From: Sent: To: Cc: Subject: Attachments: Frank Cassidy Thursday, September 26, 2024 2:11 PM Carter Nevill Department Heads Fw: Flooding on Oliver city road image001.jpg

Our Stormwater Administrator inspected the area and found there were clogged storm pipes downstream of the development causing a backup. This didn't allow the water to release quick enough to provide relief for what was occurring upstream. This makes sense since Mr. Teigen's property is not located within the mapped FEMA floodplain. The contractor is currently flushing the downstream pipe to remove the debris and sediment that accumulated in those pipes. This is a private matter between the developer and Mr. Teigen. Please let me know if you have additional questions.

# SITE DEVELOPMENT PLAN WARRENTON CROSSING TOWN OF WARRENTON, VIRGINIA (REVISION)

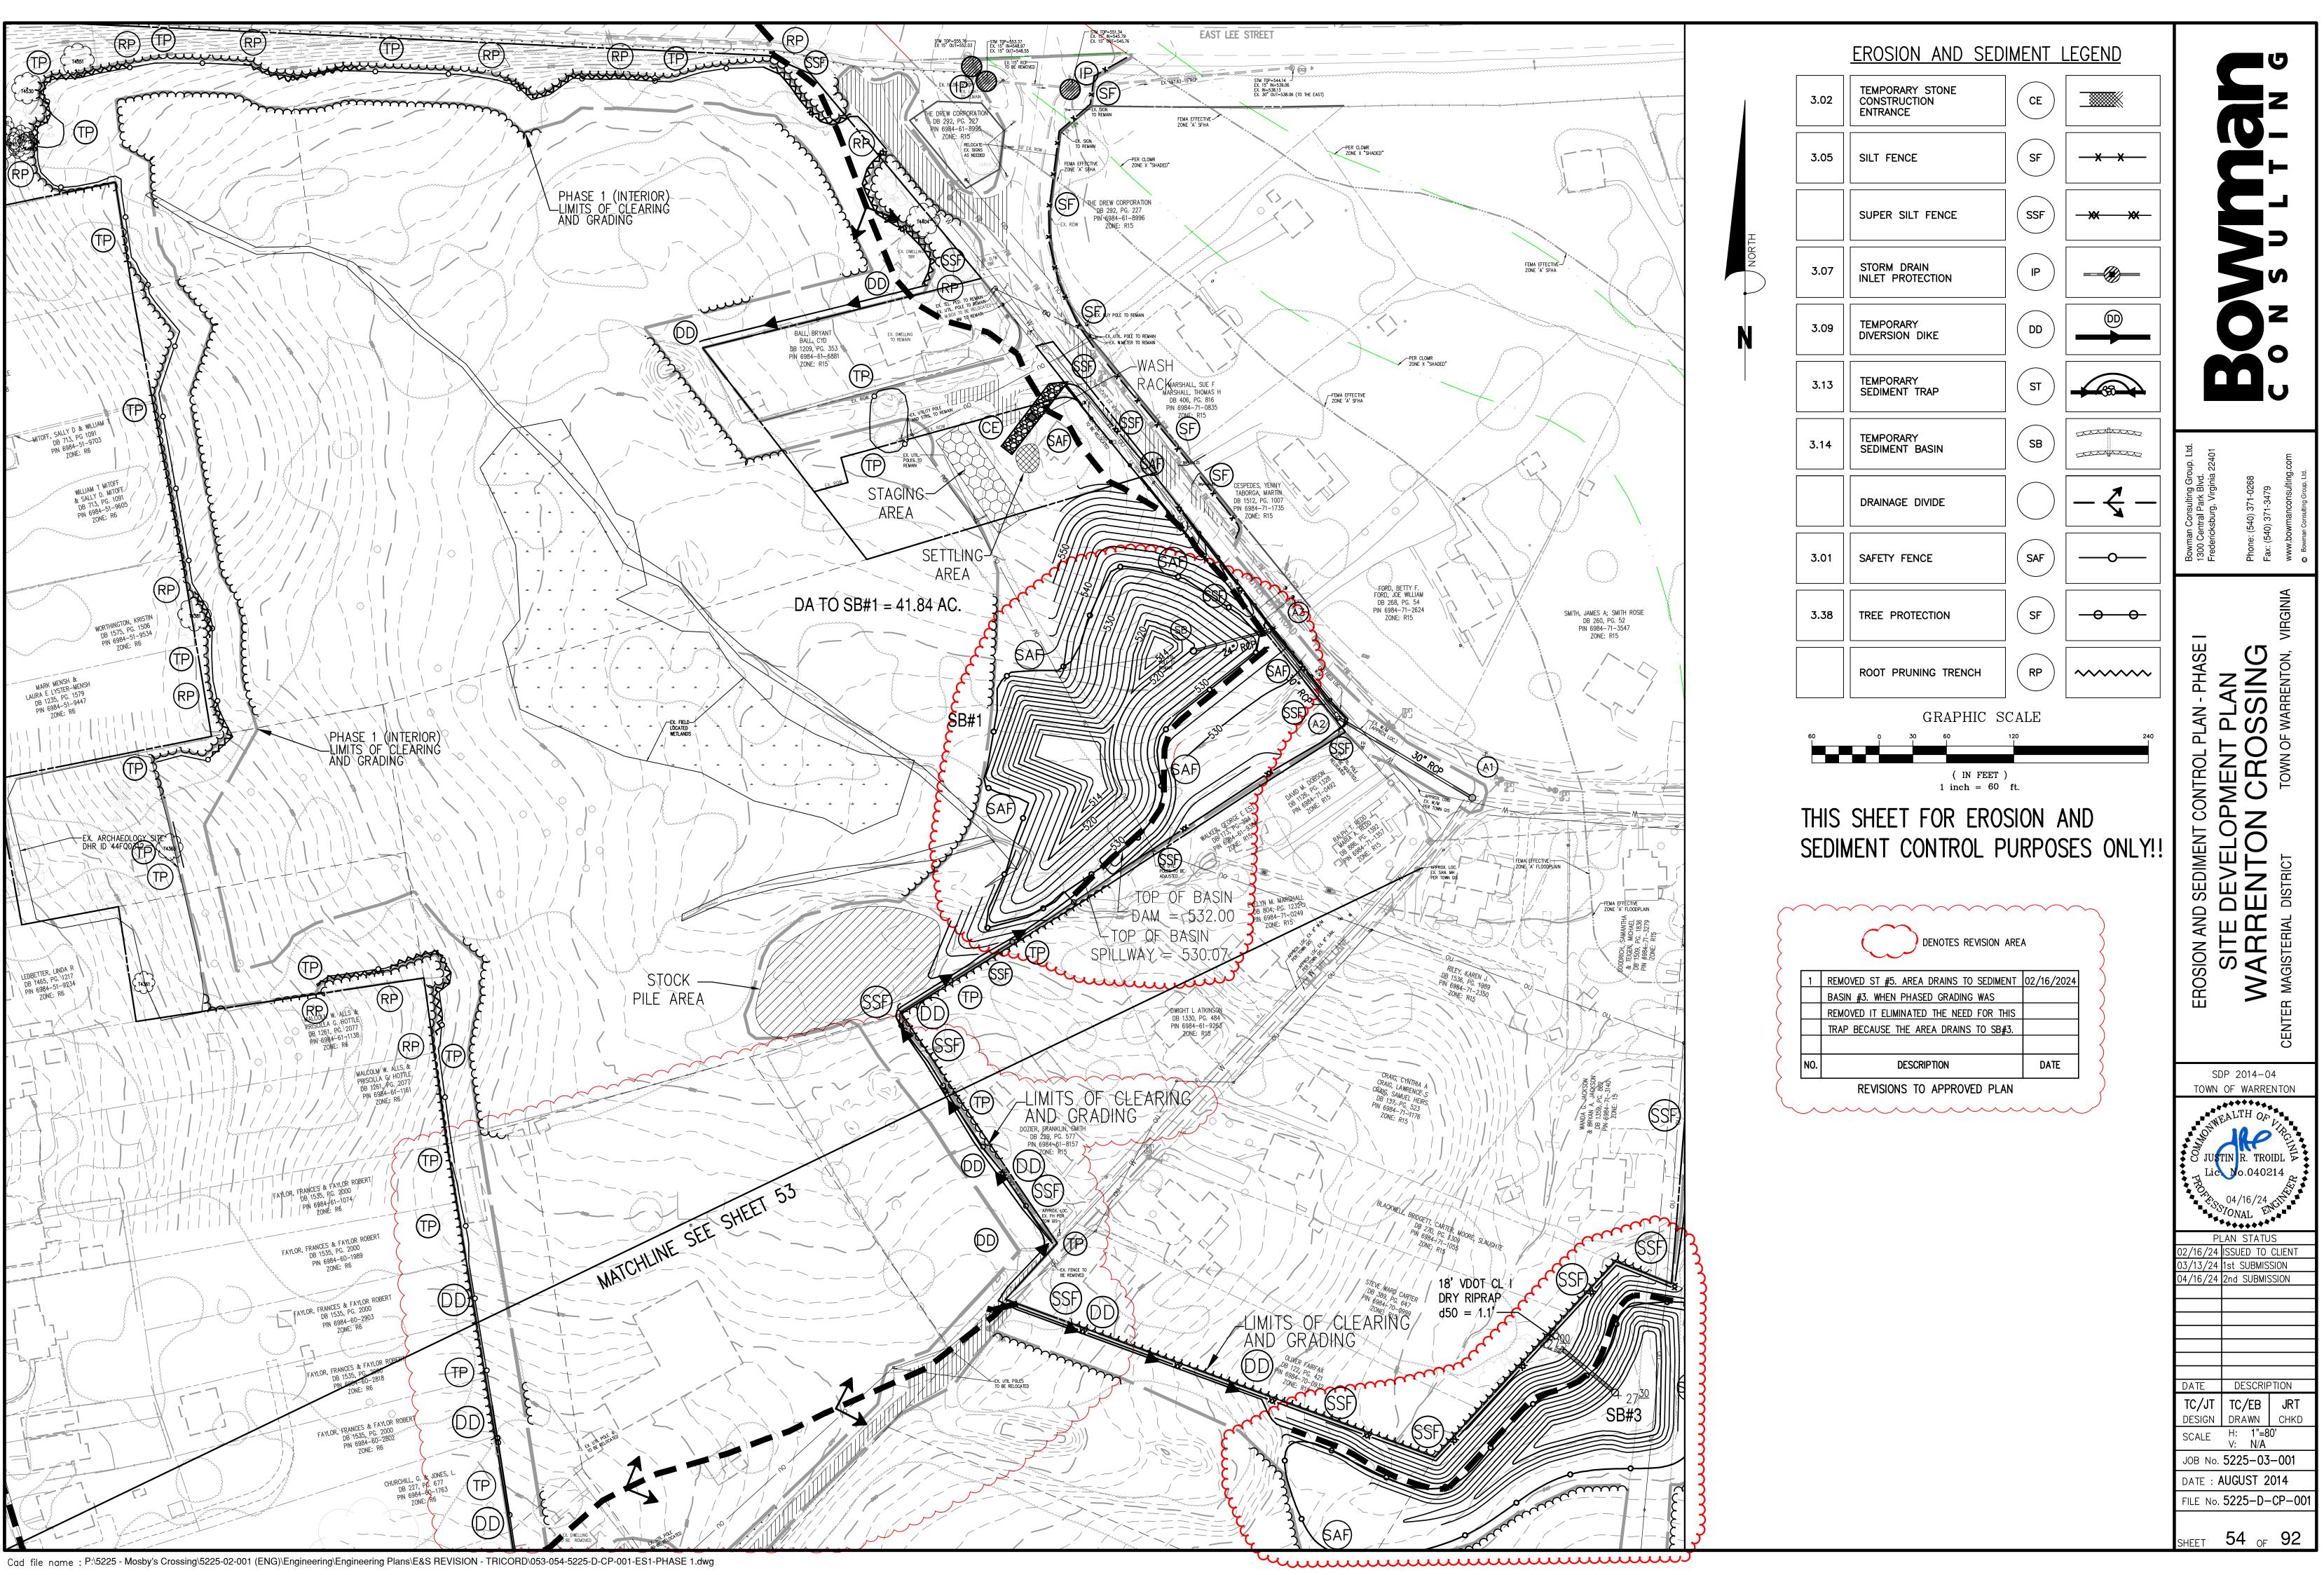
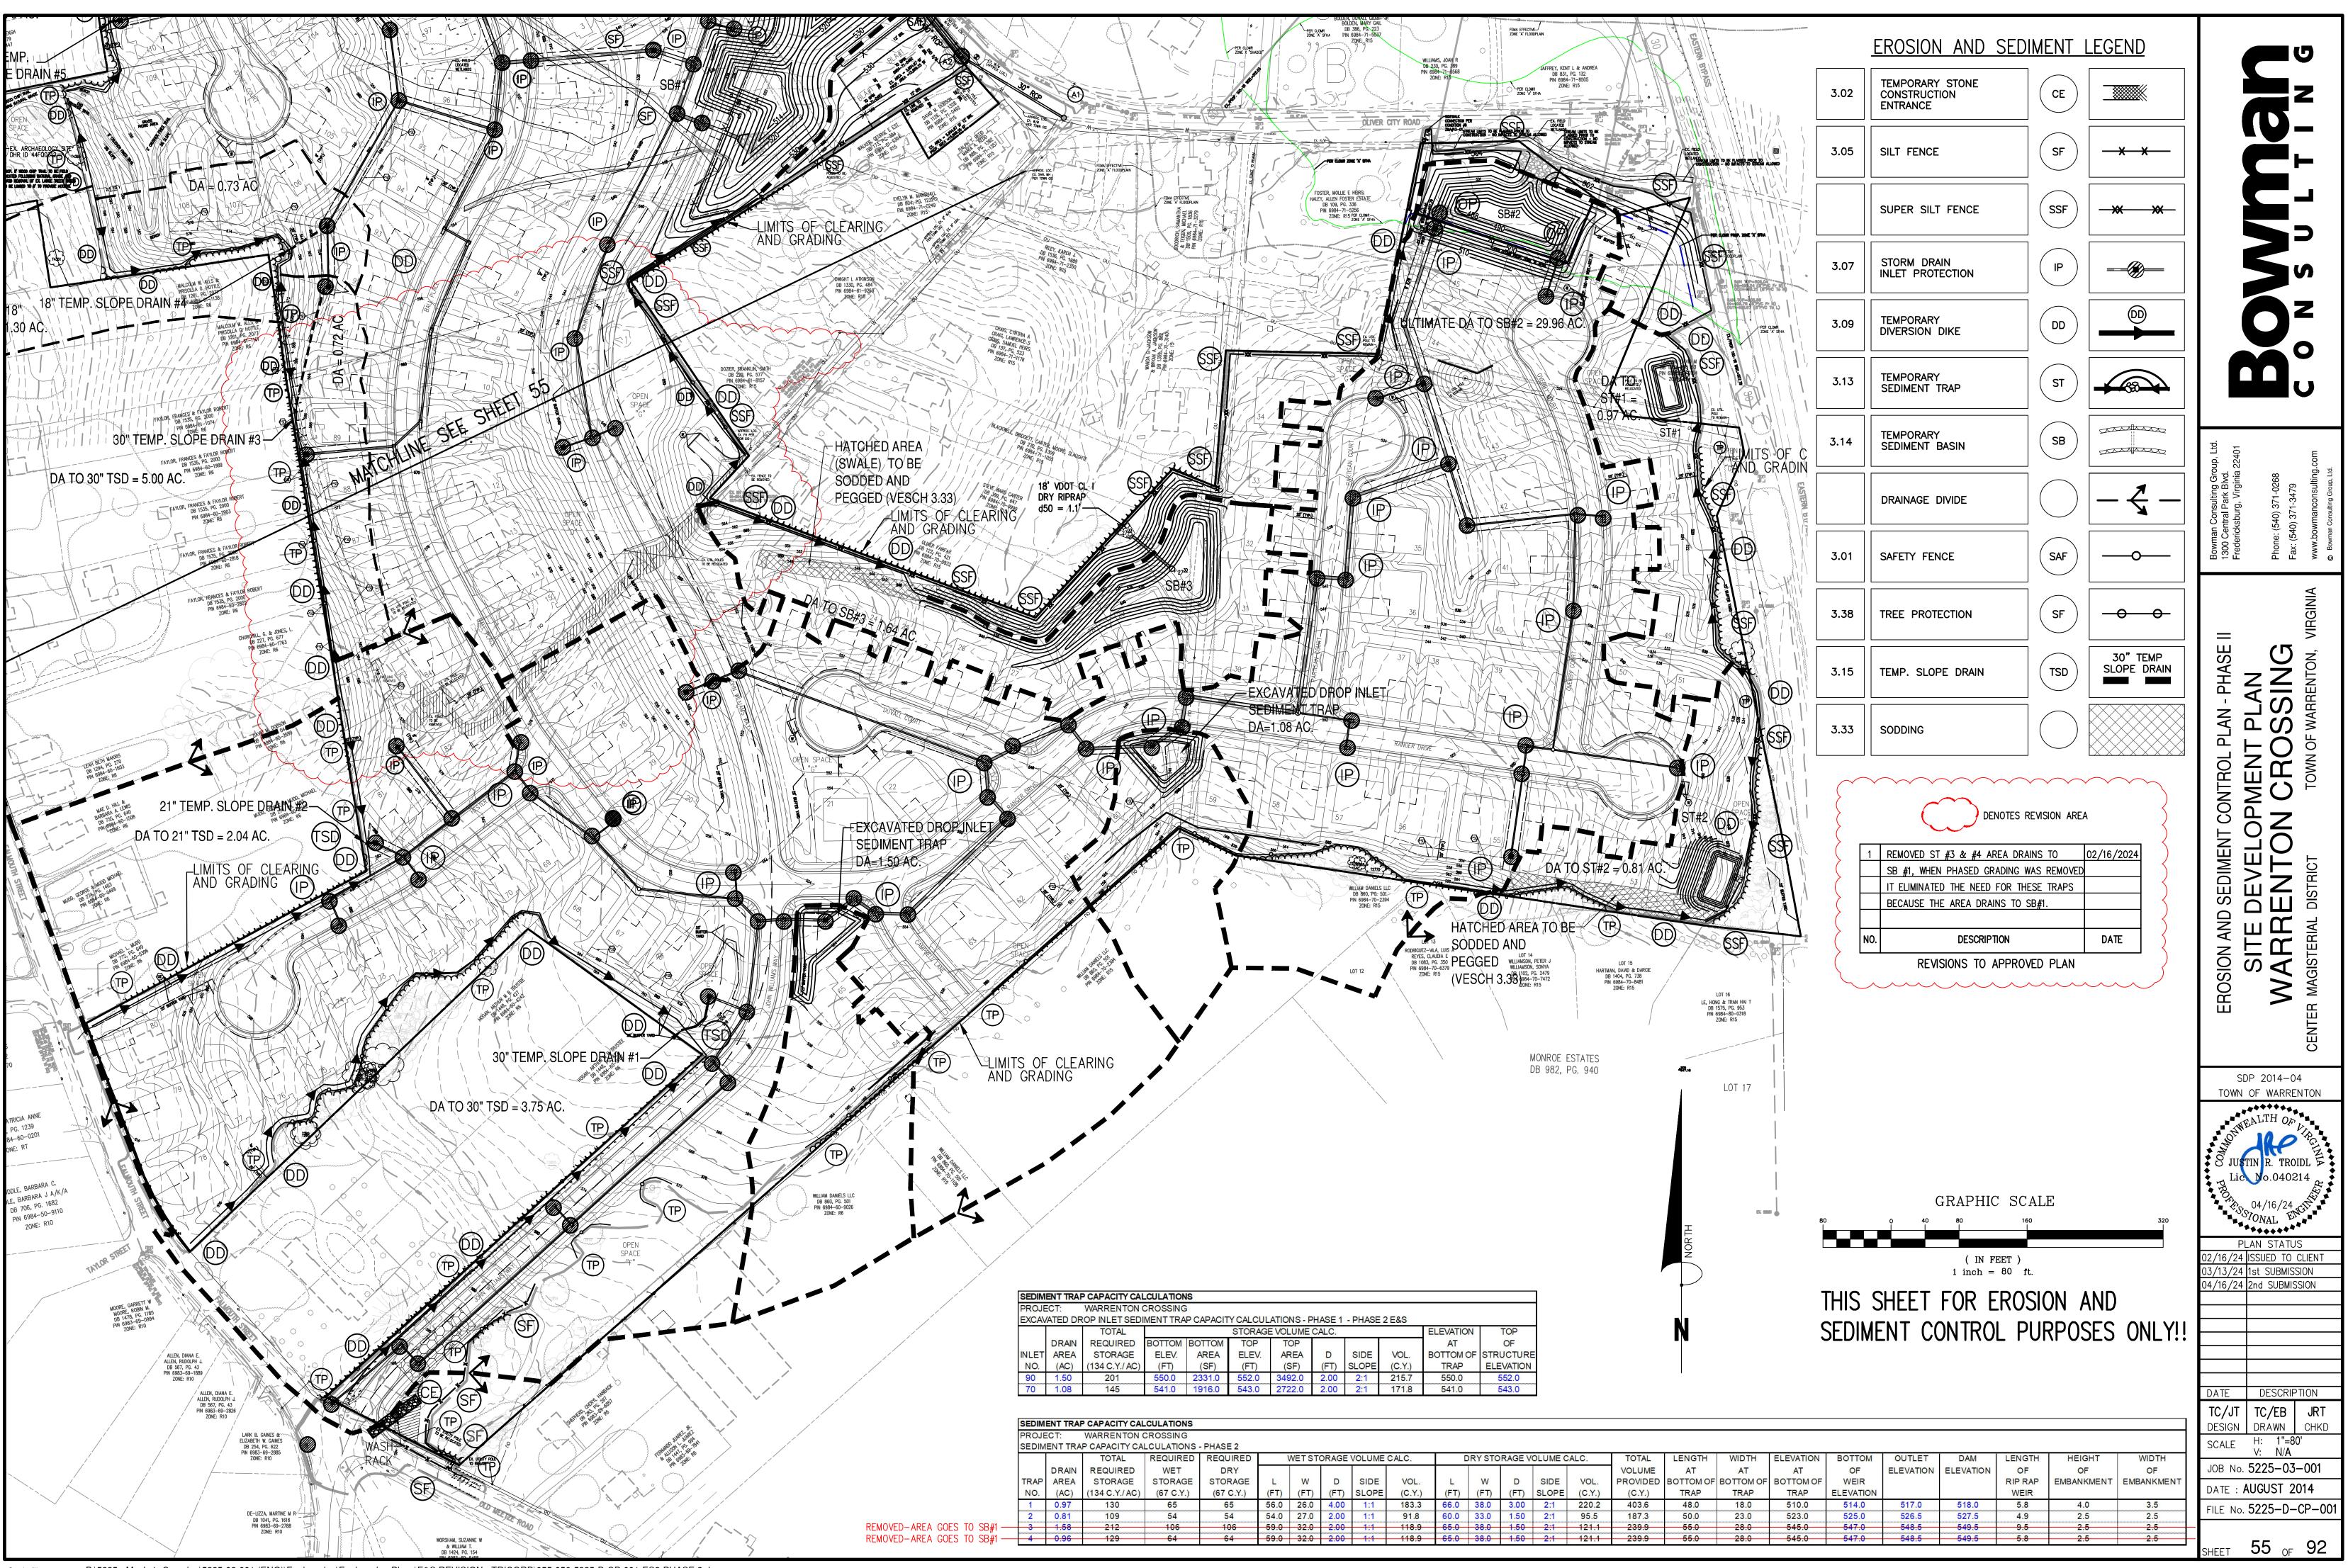
I note Sediment Basin #3 is not referenced in the SWM Maintenance Agreement (attached), consistent with Mr. Teigen's understanding that as advised for the first time today, SB#3 is only temporary, but I cannot readily find anything that definitively dictates its future disposition, as it appears on the Phase 2 sheets (see Page 4) and its removal is not referenced under the Construction Sequence Notes, Phase II E&S, page 6. (Conversions to SWB Ponds of Basins #1 and # 2 are shown). Is there a possibility it *could* be converted to a SWB Pond in a future Site Plan Amendment?

E&S, page 6. (Conversions to SWB Ponds of Basins #1 and # 2 are shown). Is there a possibility it *could* be converted to a SWB Pond in a future Site Plan Amendment?

Sediment basin #3 is a temporary basin that will only remain until the storm structures are in installed to convey water to sediment basin #2. The reason for sediment basin #3 to be shown on phase 2 of the plan is to remaind contractors that the basin is to remain in place until all the infrastructure is being graded and constructed. The sediment basin cannot be removed until approval is received from the erosion & sediment control inspector. It is likely that sediment basin #3 will be removed once they are ready to complete the pad sites for the future homes, by the time this will occur, infrastructure will be in its place to convey water to sediment basin #2. The remaining sediment basin 1 & 2 will not be converted over to their permanent pond design until all upslope areas are stabilized with vegetation which includes homes built and yards are stabilized. Due to the storm sewer installation and placement of the houses, there is no reason for sediment basin #3 to remain long term and be converted over to a permanent stormwater pond. The entire plan would need to be amended requiring significant changes if sediment basin #3 became permanent. Sediment basin #3 is currently collecting 26.72 acres and the drainage area will be reduced to approximately 2 acres when the project is complete.
